Interactive comment on “Calibrating a New Attenuation Curve for the Dead Sea Region Using Surface Wave Dispersion Surveys in Sites Damaged by the 1927 Jericho Earthquake” by Yaniv Darvasi and Amotz Agnon

Yaniv Darvasi and Amotz Agnon

Received and published: 16 December 2018

Fig. 1. Sensitivity analysis for calibration the new equation.

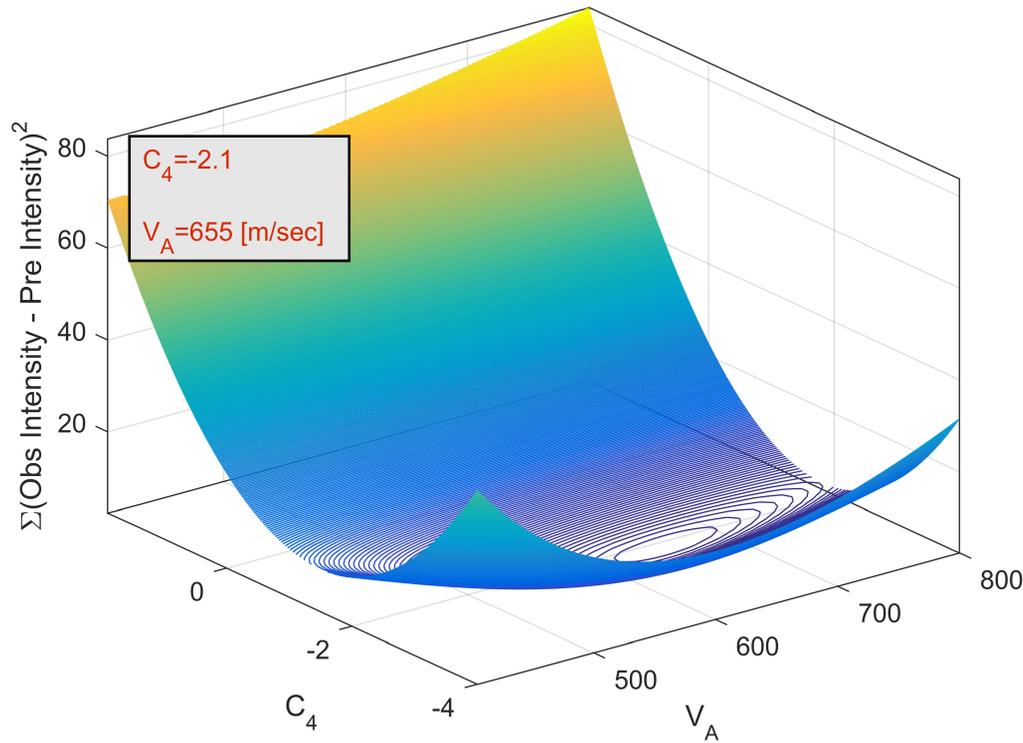
(1) No sensitivity analyses were performed.

(2) We thank the reviewer for the point and we include the sensitivity tests in the new version.

(3) See page 8 (section 4.2). Also, fig11

Fig. 2. Avni's seismic intensity (MMI) estimates of all 133 sites. Distance is corrected according to Zohar & Marco epicenter. Yellow dots suspected amplified or de-amplified sites. Sites with pin are sites w

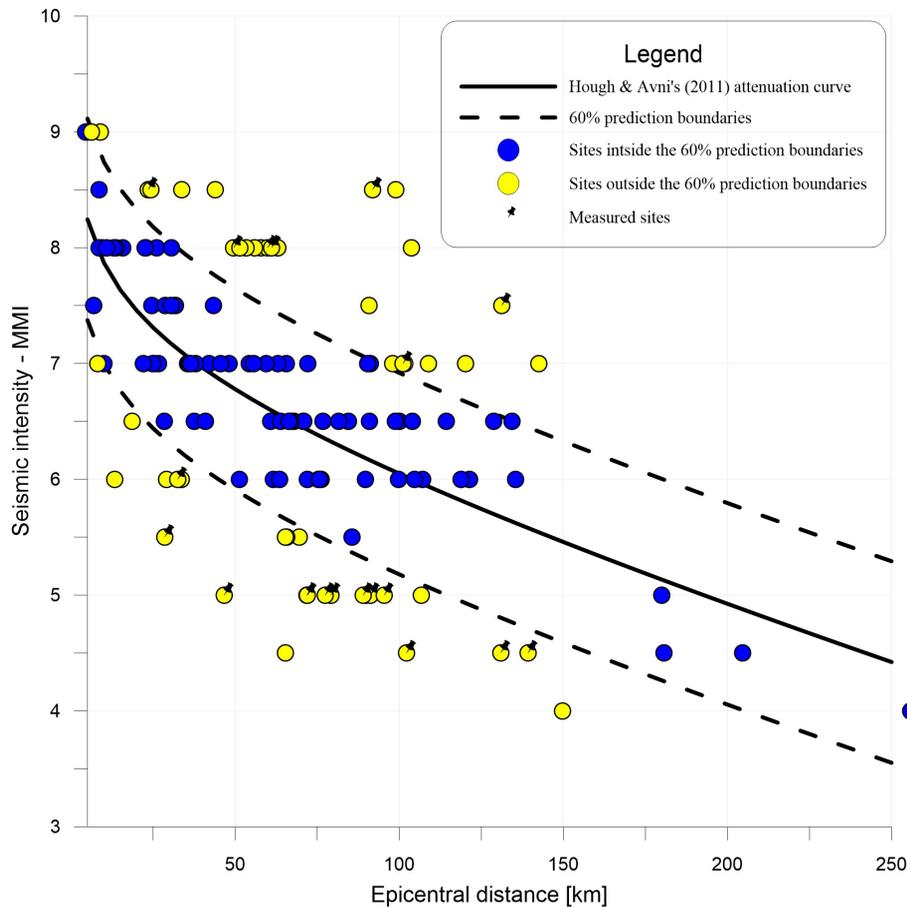
(1) The authors fail to discuss or at least mention other research regarding this exact earthquake, such as Kadmiel et al. (2015, SCEC). I think it would be interesting if the authors try to use the data from Zohar and Marco (2011), which attempted to correct the intensities of the 1927 EQ to site conditions, such as surface geology, slope and construction. Zohar and Marco's work should at least be mentioned, as they did try to deal with the site response biasing the intensity reports.

- (2) We mentioned the significant work of Zohar and Marco (2012 instead of 2011) and used their modern epicenter location for our calculation.
 - (3) We added a comment about Kadmiel work.
-
